PLEASANT VALLEY ROAD / I-77 SB RAMP
/ FORESTWOOD DRIVE INTERSECTION
'BUILD ALTERNATIVE 1'
SHEET 1 OF 3

PLEASANT VALLEY ROAD / I-77 SB RAMP / FORESTWOOD DRIVE INTERSECTION 'BUILD ALTERNATIVE 2'

FIGURE 6

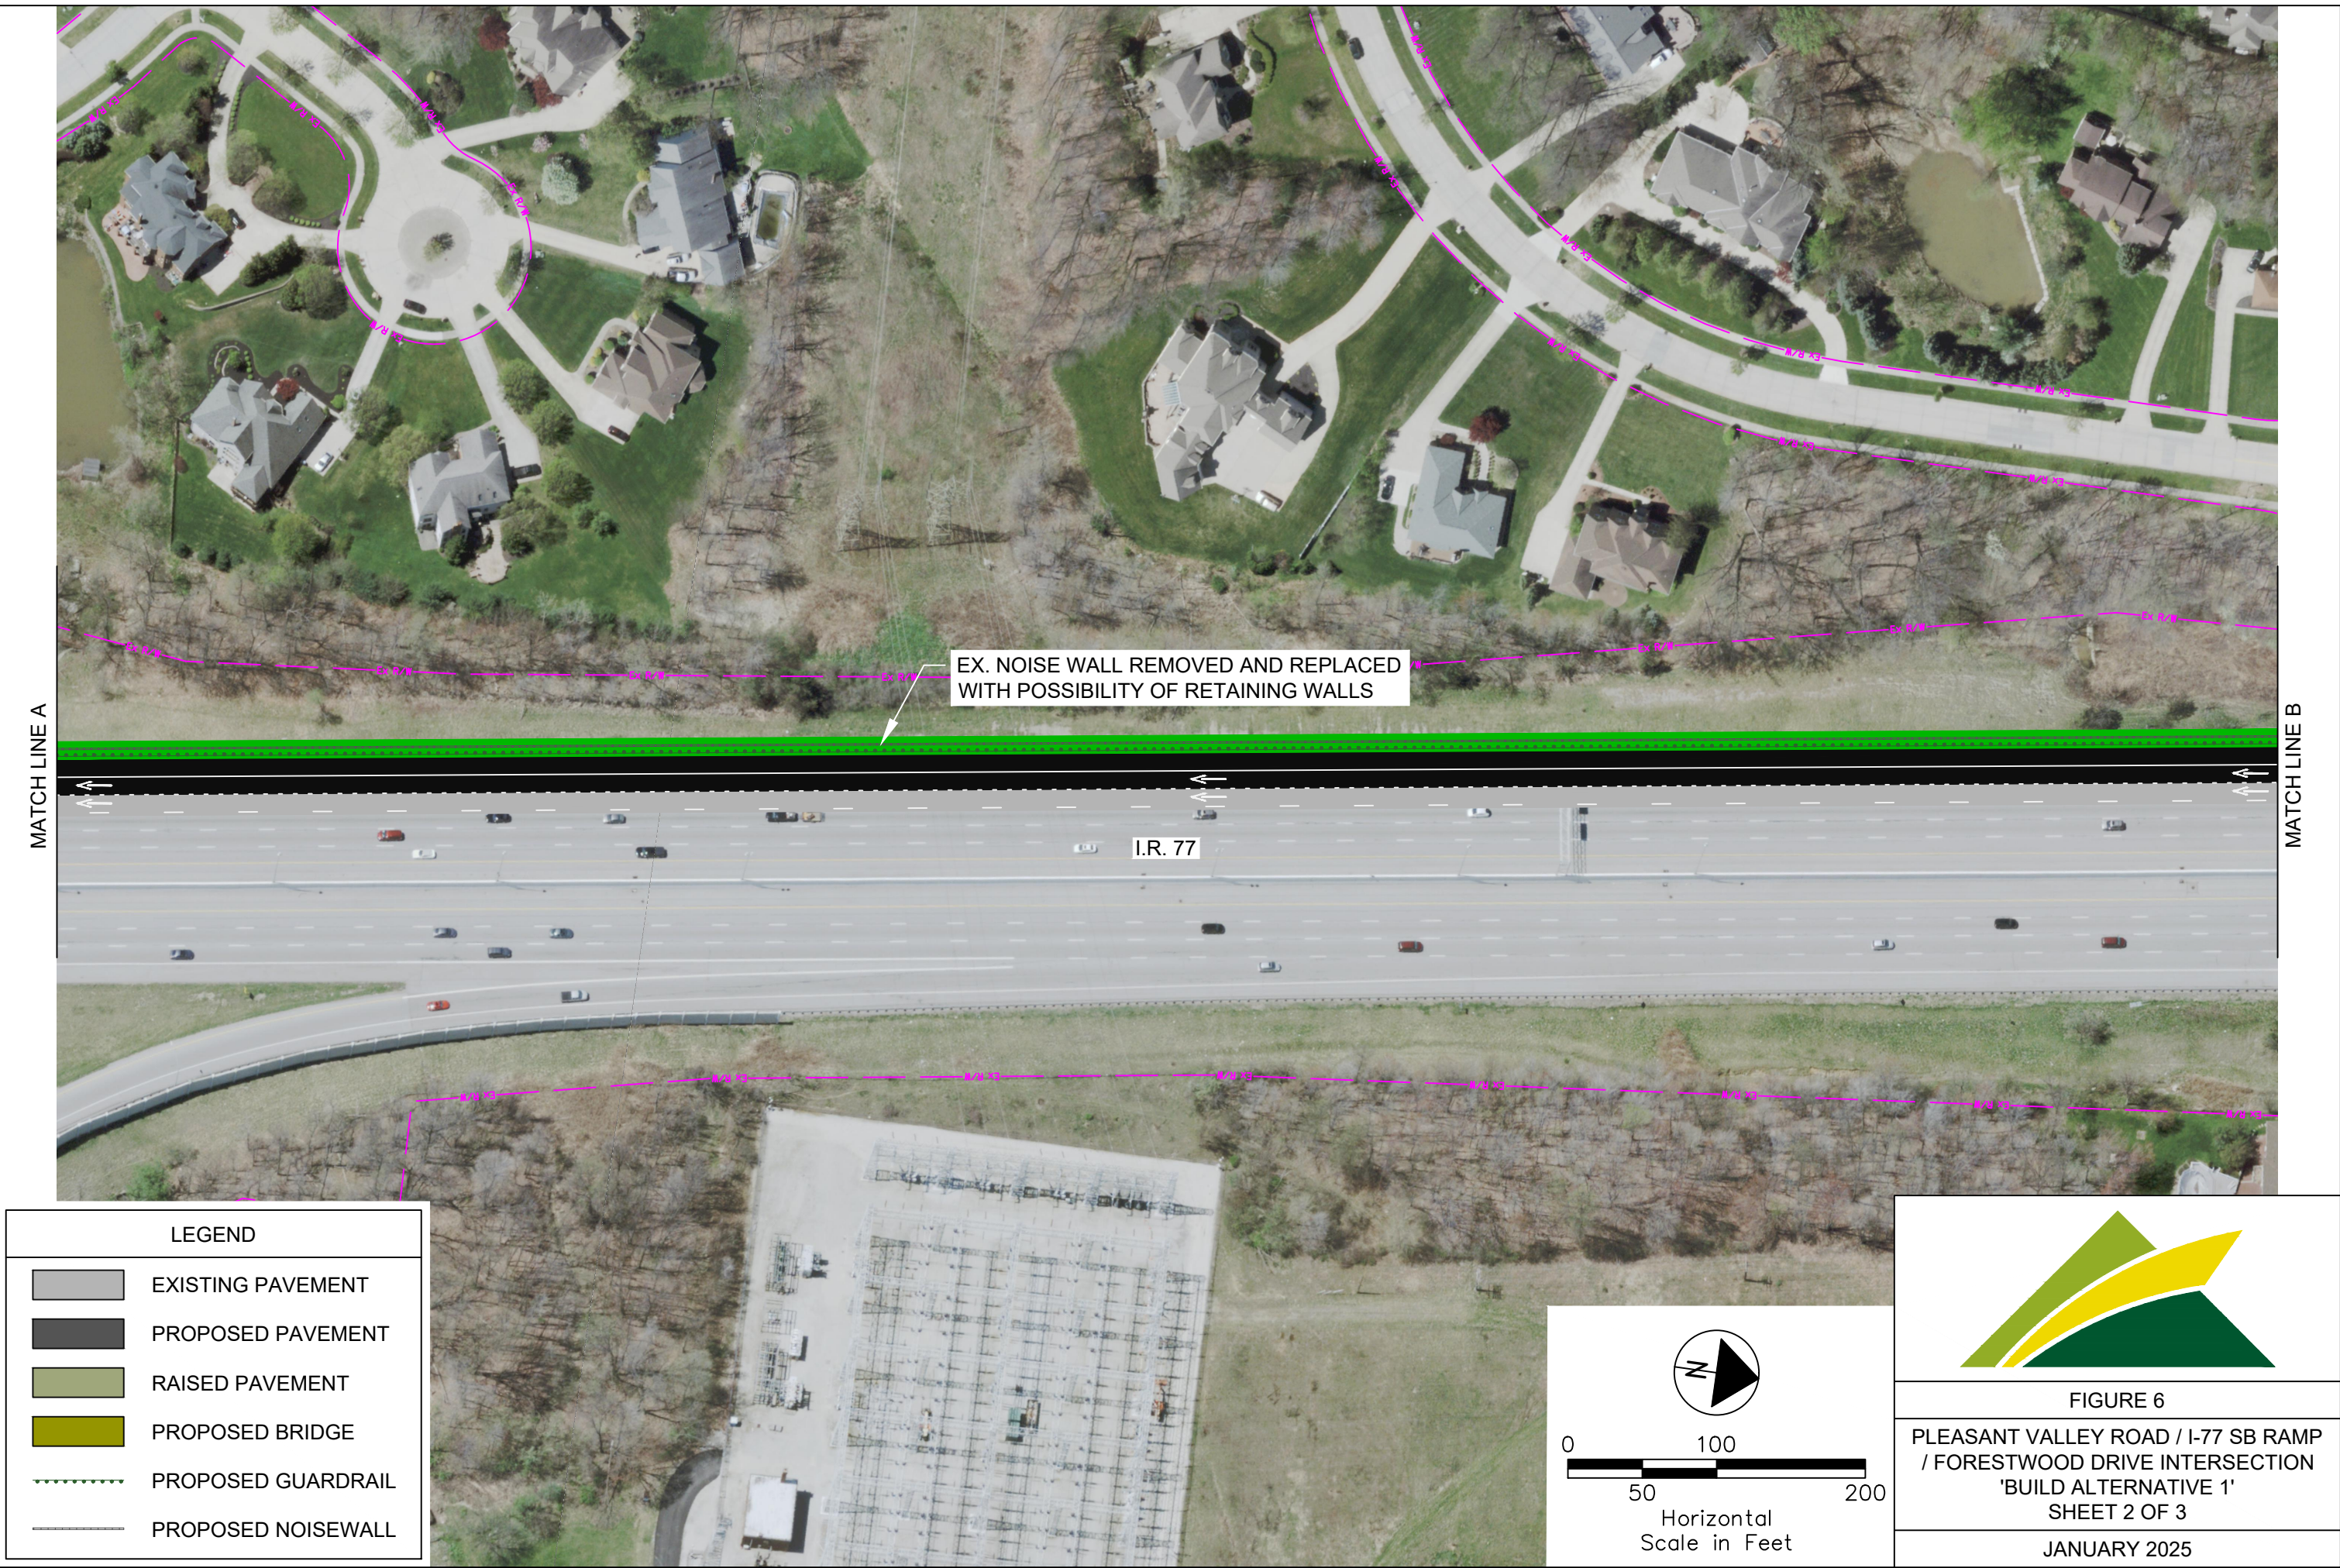
The first concept ODOT wishes to see the City explore is whether the Forestwood Dr approach could be restricted to RIRO access, with alternate access to Pleasant Valley and I-77 SB provided via indirect left turns and/or potentially creation of new connectivity between the Forestwood subdivision and Pleasant Valley. ODOT should have never allowed full movements at this intersection when the city proposed it in the early 1990's. That was a huge mistake.

ODOT requests an alternative that aligns NB-SB left turners head-to-head so that NB-SB left turn movements can occur concurrently and terminate independently. ODOT views the fact that Forestwood was originally built with a negative offset for SB left turns (resulting in overlapping turning paths for concurrent left turns) as the primary flaw in the design of the approach to this intersection. It should be corrected first before further modifications of I-77 are considered.

FIGURE 7

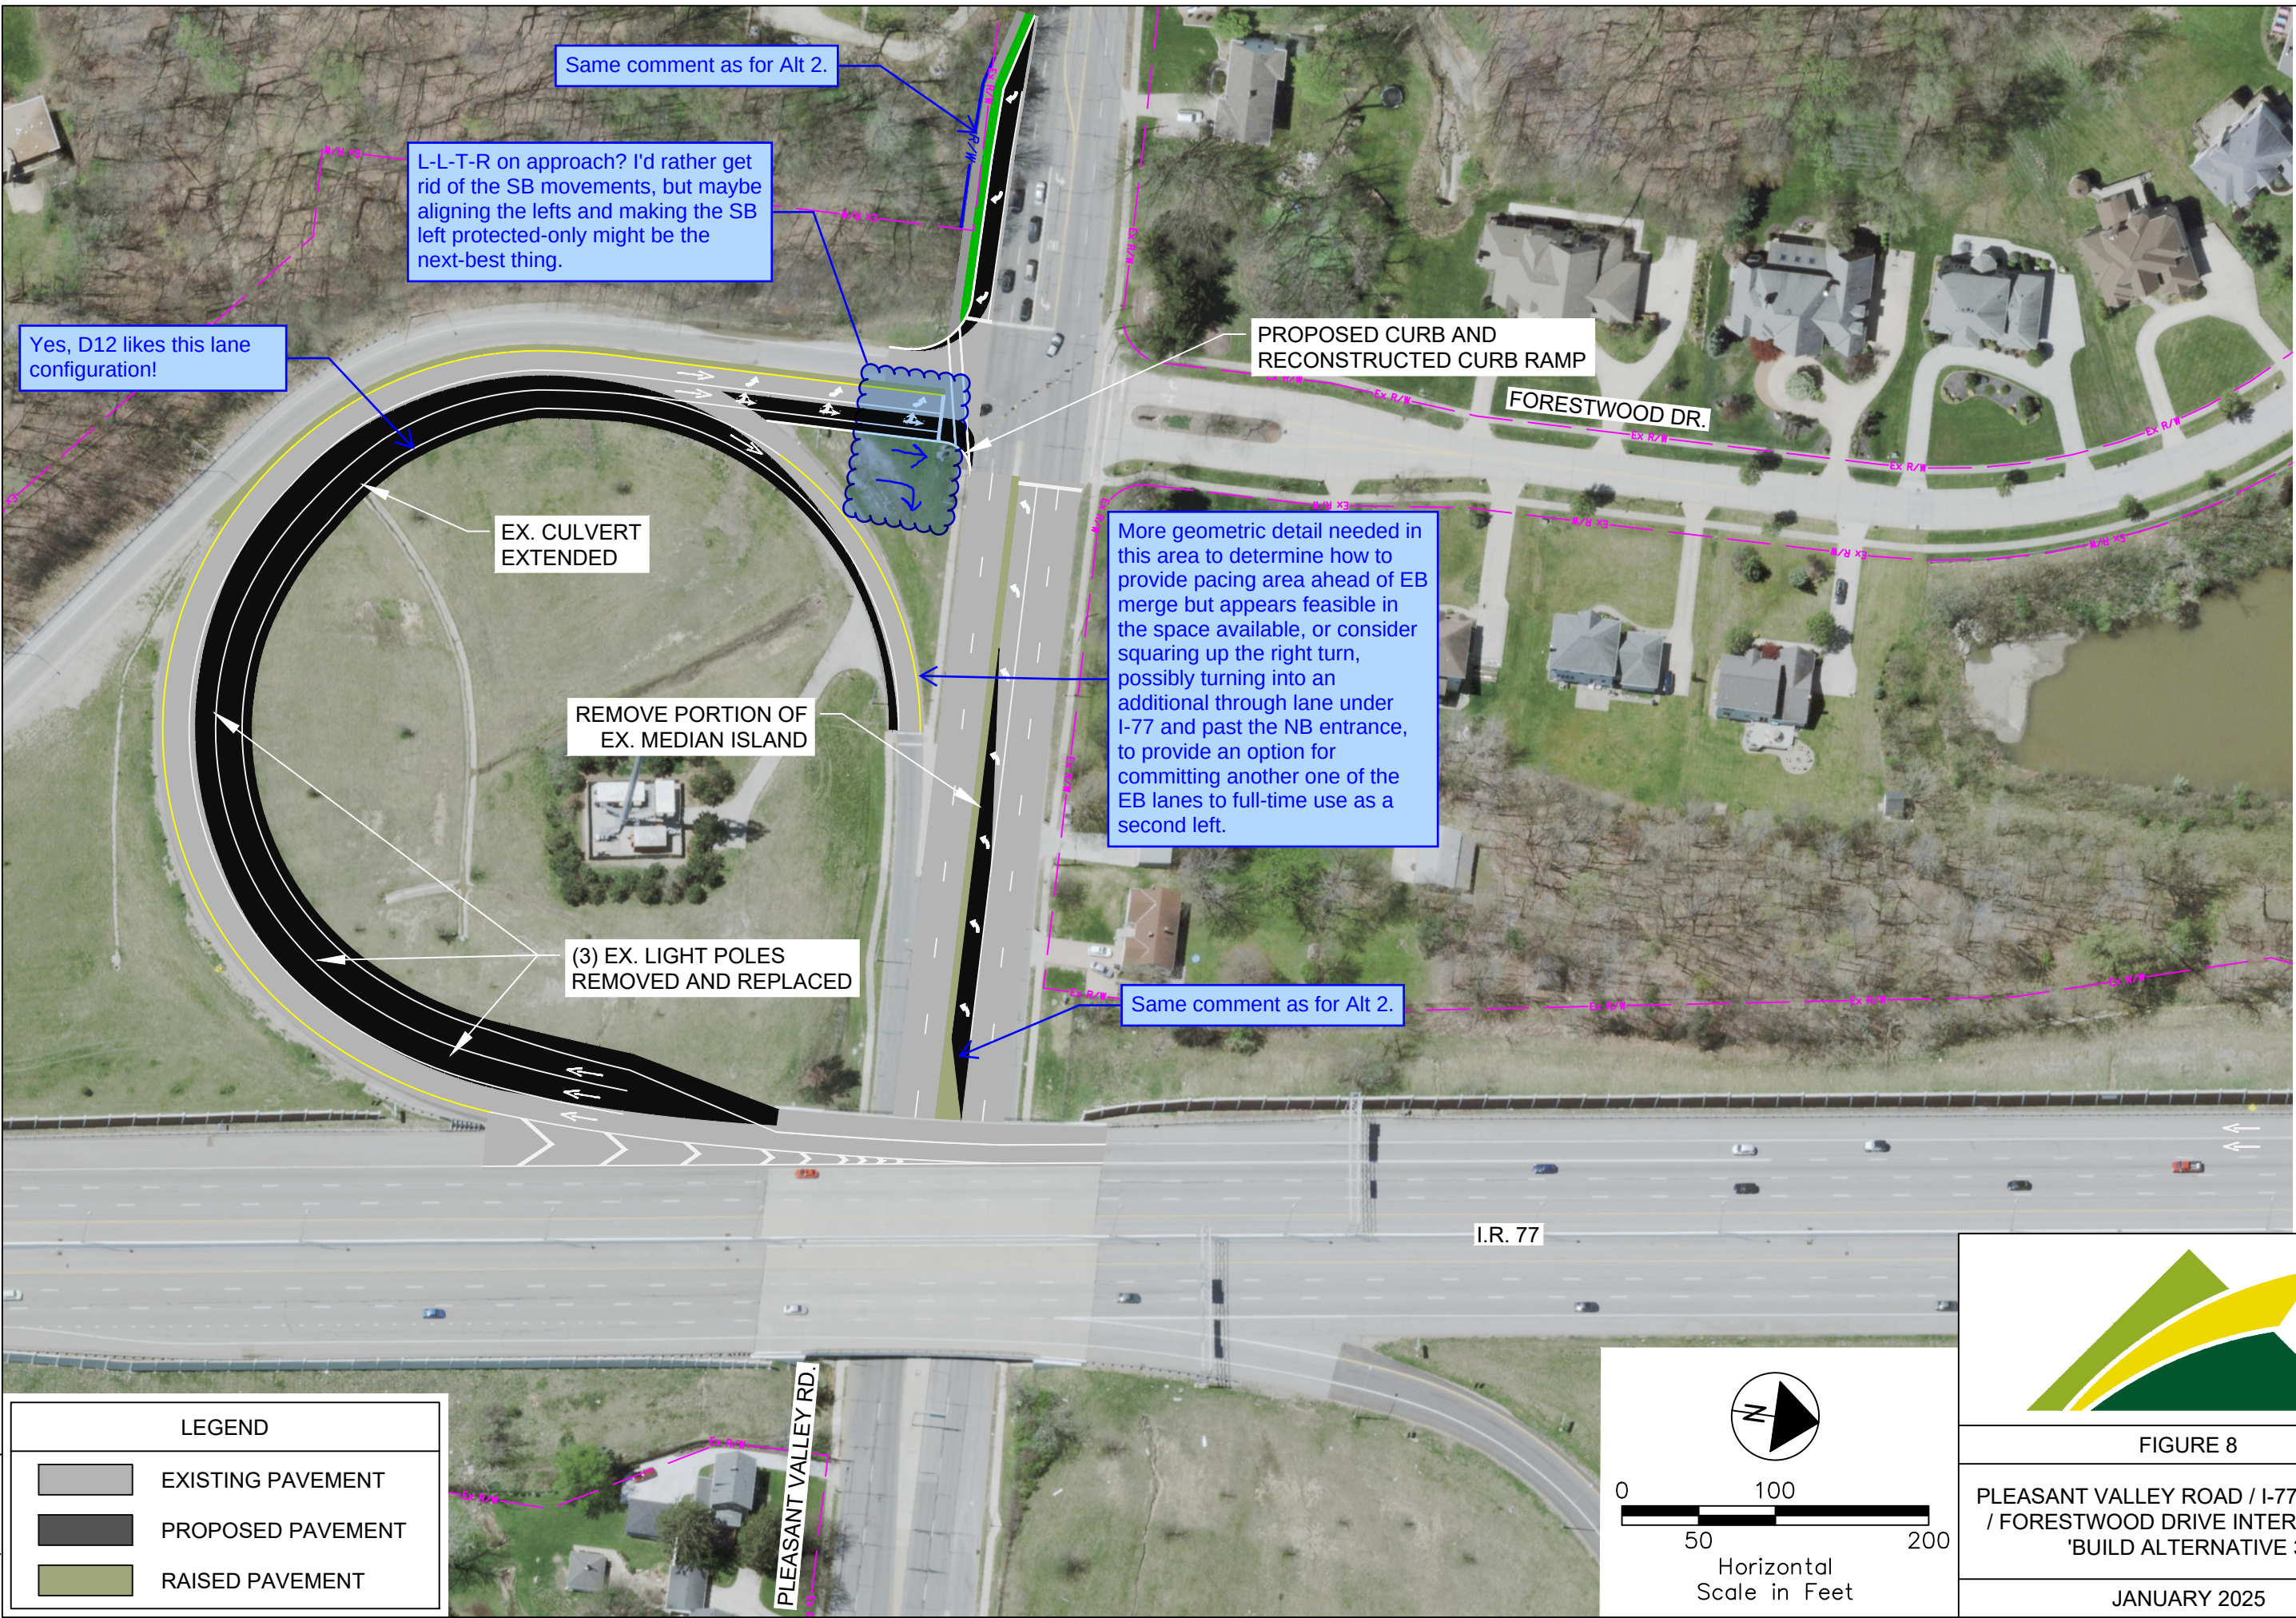
This configuration still remains susceptible to queue-blocking. Why not develop a right-turn only lane further up the ramp on the inside of the loop? Oops, nevermind, I see that's proposed in Alternate 3.

Try to avoid this sign to avoid additional expense for not much more storage...

A 375' left turn lane almost meets the storage length based on turn demand (425') but is still short on through-queue block (625').
